FINAL FINDINGS AND DECISION BY THE DESIGN
COMMISSION RENDERED ON June 7, 2012

CASE FILE NUMBER: LU 12-115245 DZ
PC # 11-171488

Glisan Commons

1C.5 - MASTER PLAN DIAGRAM

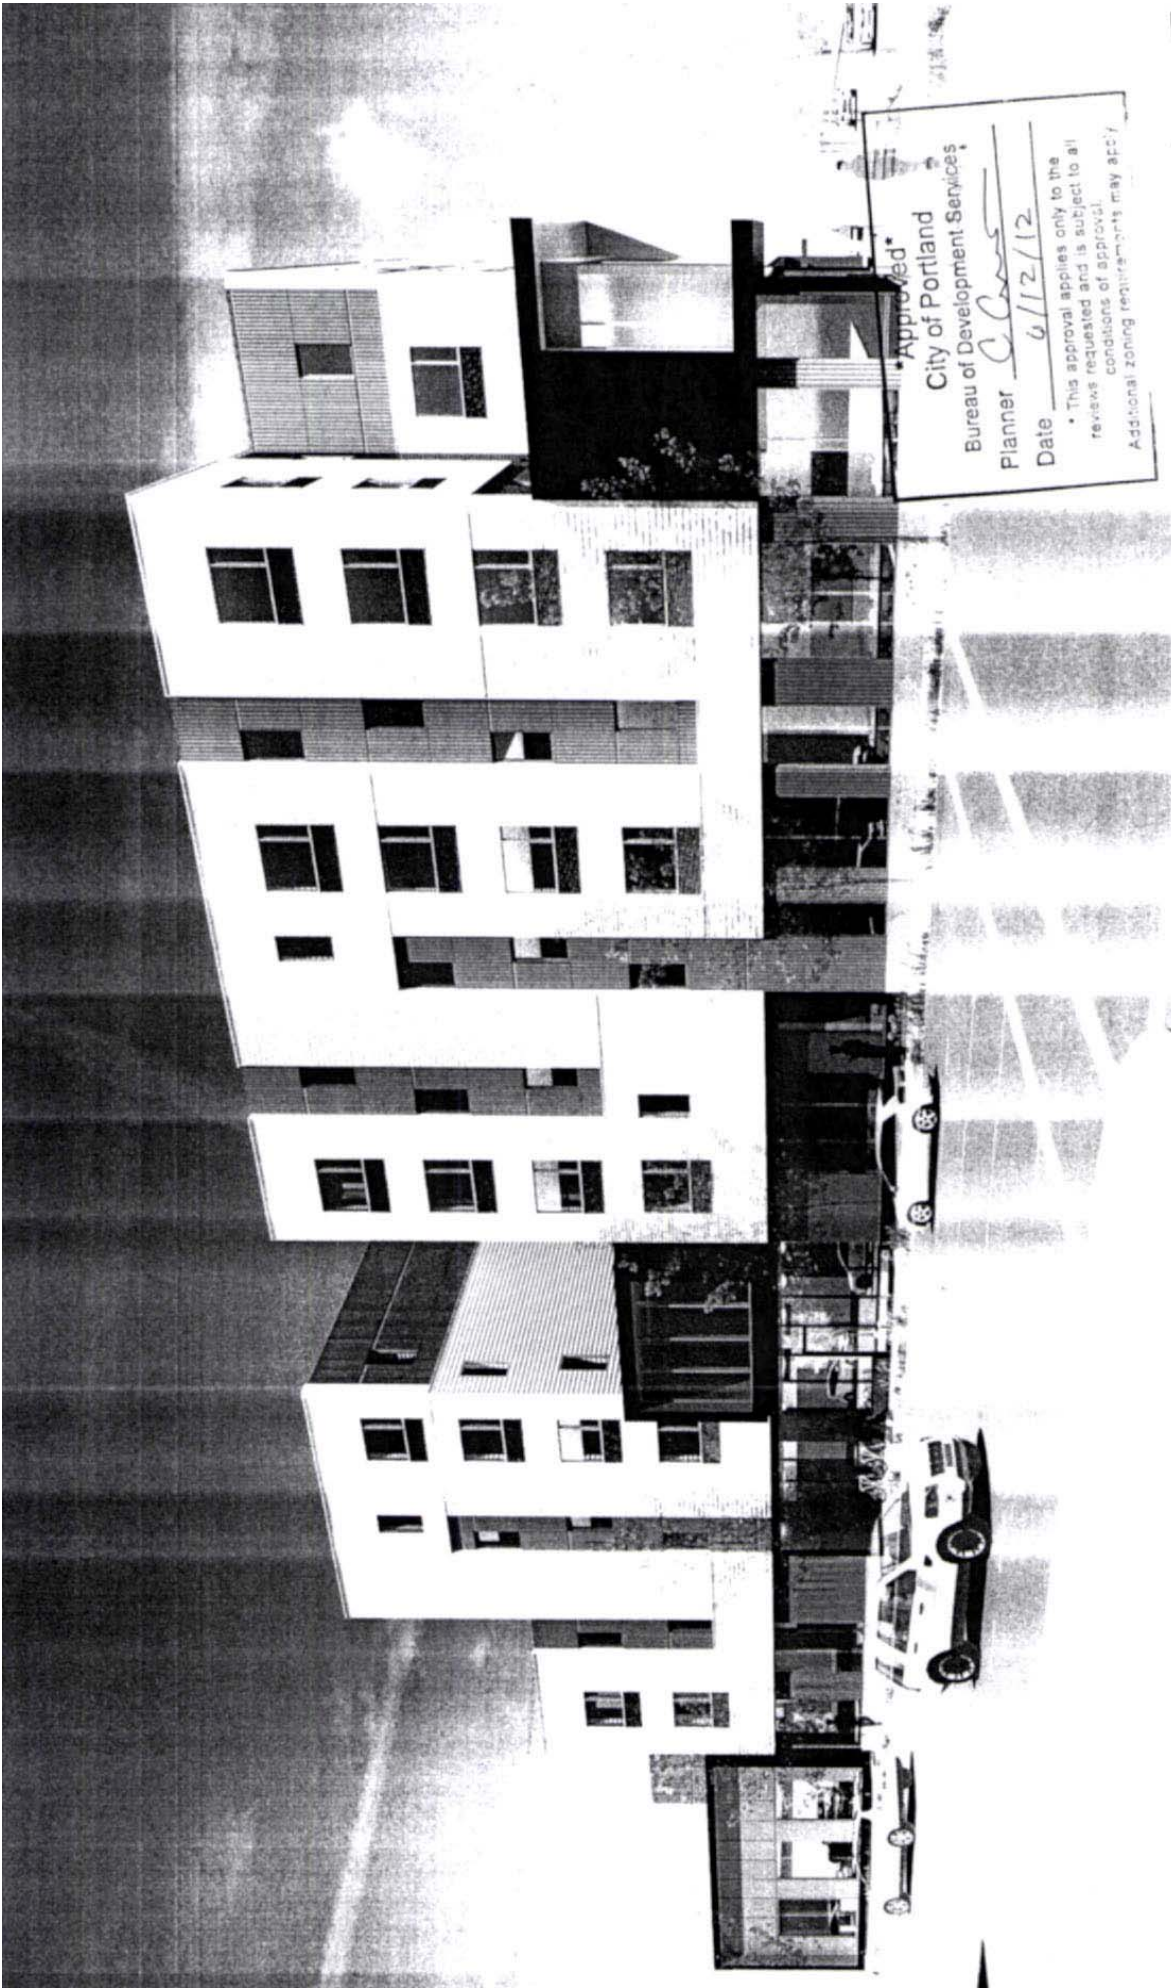
2. The site plan accurately reflects the dedications and street improvements identified in PBOT's Pre-Application response. Based on review by PBOT traffic engineering during the public works permit review, changes to the driveway designs and parking lot layout will be required as a condition of building permit and public works permit approval. The current design with two driveways in close proximity on NE 100th Avenue has the potential to create unsafe conflicts with pedestrians and vehicle circulation at the driveway entrances within NE 100th Avenue. If a vehicle in the southern driveway was turning northbound on NE 100 at the same time a vehicle leaving the northern driveway was turning southbound, unacceptable vehicle conflicts would occur. In addition, by adding 6 parking spaces in the double loaded lane between the driveways all the way up to the frontage, the design uses the public right-of-way for parking lot circulation which is not allowed. To mitigate for these impacts, the following three conditions of approval will be required. These conditions of approval have no impact on the Phase 1 parking layout and operation.

- The northern driveway on NE 100th Avenue shall be eliminated from the plans.
 - The 6 double loaded parking spaces between the driveways closest to NE 100th Avenue shall be eliminated to provide for internal parking lot circulation.

PBOT response to applicant inquiry and sketch proposal: The applicant has changed the Gateway Master Plan drawings of the parking area to indicate the removal of the northern driveway, removal of one of the six parking spaces in question, and striping of a second of the six parking spaces to allow backing up, all to be done as part of Phase II construction. The Portland Bureau of Transportation has indicated via email that these changes are acceptable (Exhibit E-7). The last three conditions requested by the Portland Bureau of Transportation in their Item 5. Recommendation. above, are therefore no longer necessary.
